* * * * *
 *
 * UNITED STATES *
 * DEPARTMENT OF THE INTERIOR *
 * BUREAU OF RECLAMATION *
 *
 * - - - *
 * HYDRAULIC LABORATORY REPORT NO. 32 *
 *
 * - - - *
 * MODEL STUDIES OF DOS BOCAS DAM SPILLWAY *
 *
 * BY *
 * J. E. WARNOCK and J. H. DOUMA *
 *
 * - - - *
 * Denver, Colorado *
 *
 * February 28, 1938 *
 *
 * * * * *

Guayama, Puerto Rico
November 20, 1937.

Reference is made to your letter of November 20, 1937, and office letter of November 30, 1937, concerning model studies of the Dos Bocas Dam spillway.

TAILWATER CURVES
ARCIBO RIVER
AT
DOS BOCAS DAMSITE

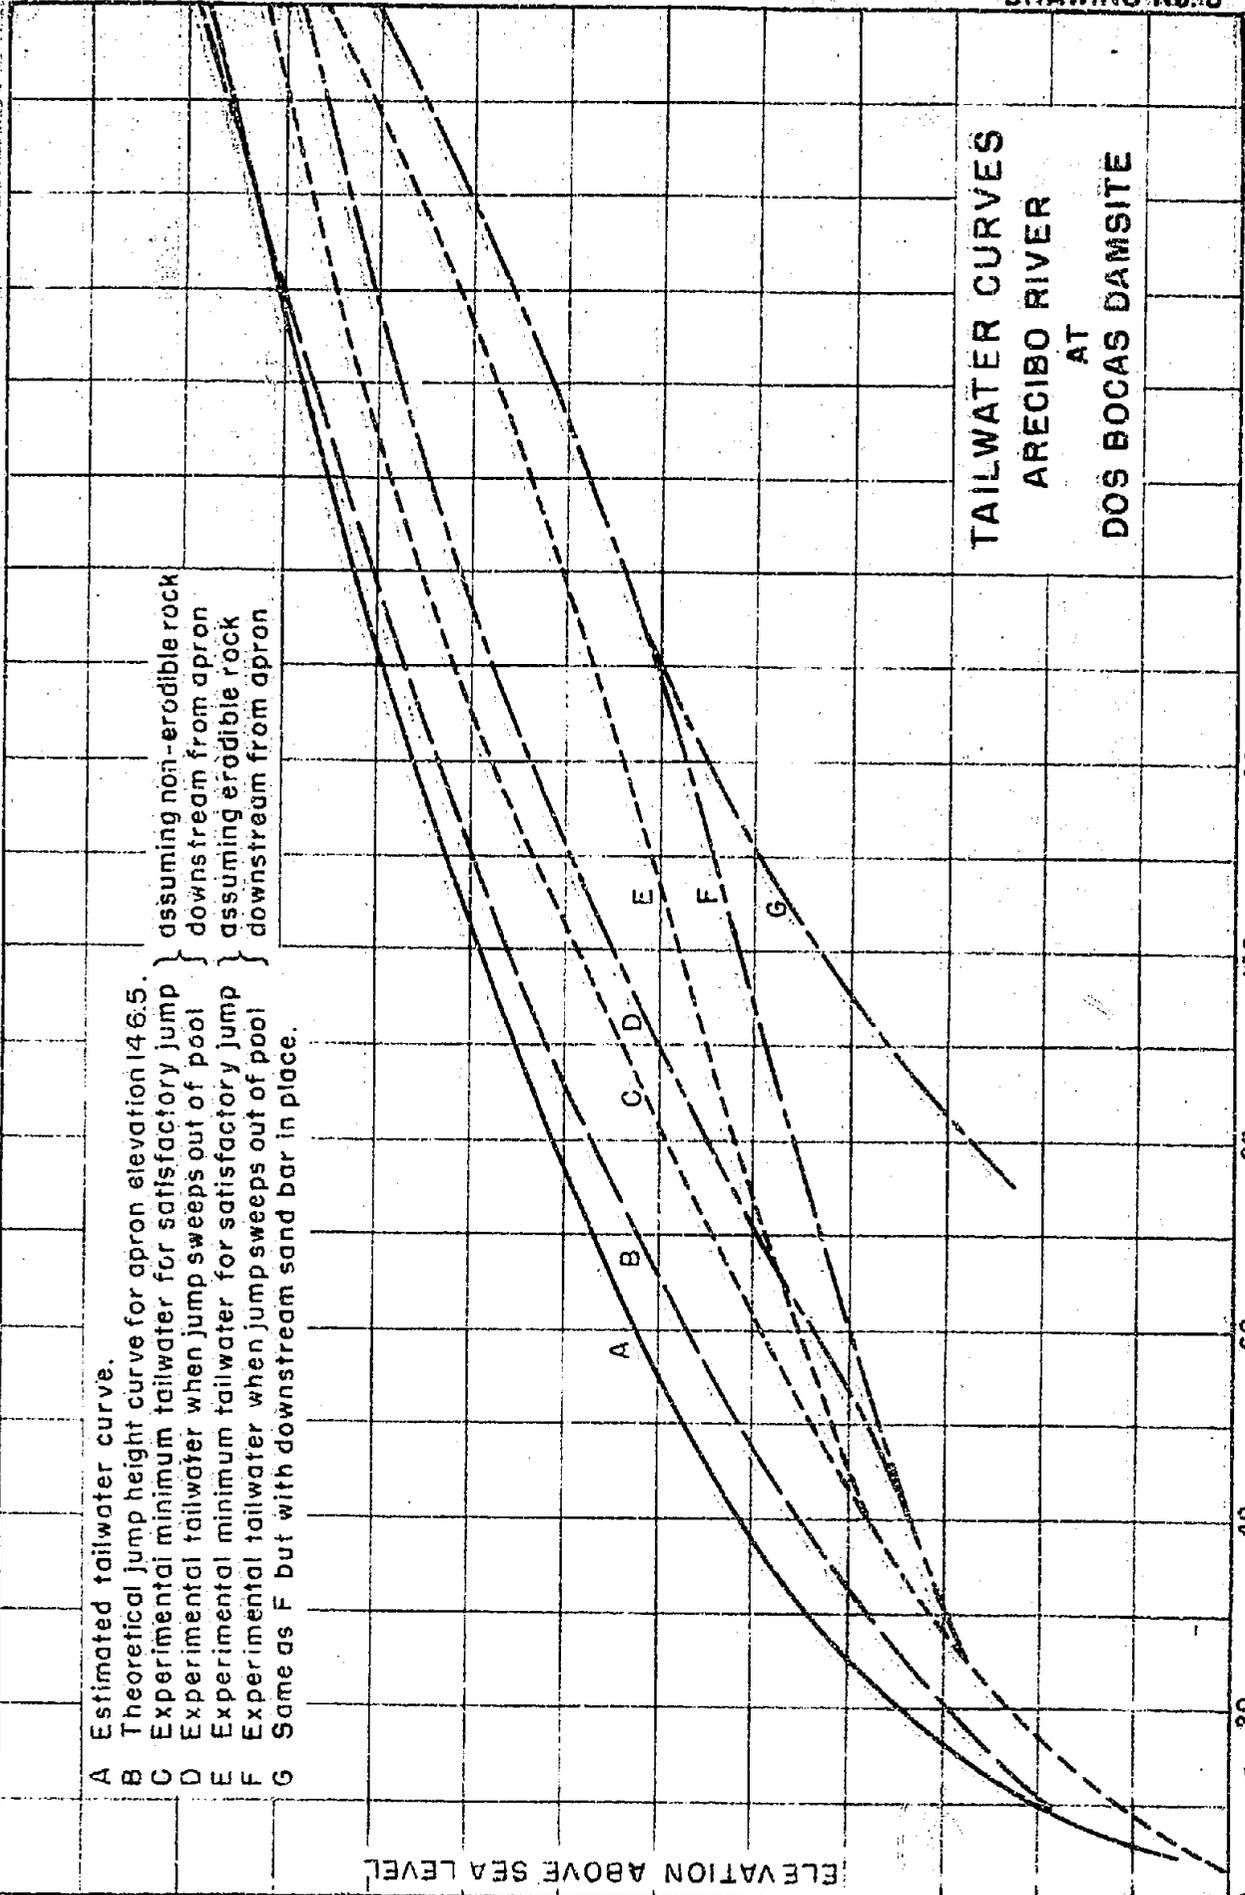
11. Hydraulic jump performance. The hydraulic jump is very effective in dissipating the energy of the overflow, the resultant velocities after completion of the jump being little greater than those normally present in the river channel during a given flow, were no dam present. The elevation of the apron is such that the hydraulic jump will form well up on the toe of the dam at all stages of the flood, and the dissipation of the tremendous energy of the falling sheet occurs by the natural action of impact of water against water (drawing No. 10). Assuming the rock downstream from the apron to be of such soundness as to resist scour completely, the tailwater may be lowered from 3 to 7 feet to curve C, drawing No. 8, without appreciably changing the conditions of flow. If the rock does scour, after maximum scour has been attained, the downstream ground roller is effective in keeping the jump in the stilling basin so that then the tailwater may be lowered from 7 to 11 feet to

curve E, drawing No. 8, and still have a satisfactory jump. When the tailwater is lowered to curves D and F the jump will sweep out of the stilling basin for no scour and maximum scour, respectively. Curves C, D, E, and F show that for flows less than 40,000 second-feet, scour does not influence the jump performance, and for flows less than 25,000 second-feet, the end sill gives sufficient D_2 depth to produce the jump on the apron without the aid of downstream tailwater. When the maximum scour has been attained the water-surface is not as smooth as with no downstream scour due to the effect of the ground roller in directing the flow upward at the end of the stilling basin, drawing No. 11. However, this condition exists only for flows greater than 100,000 second-feet and even then the condition is very much less severe at the sides where the bank scour might occur. The higher water surface at the end of the stilling basin for the maximum scour condition results in a larger surface jump roller, which is more efficient in dissipating the energy, so that a lower back pressure due to tailwater is required to maintain a satisfactory jump.
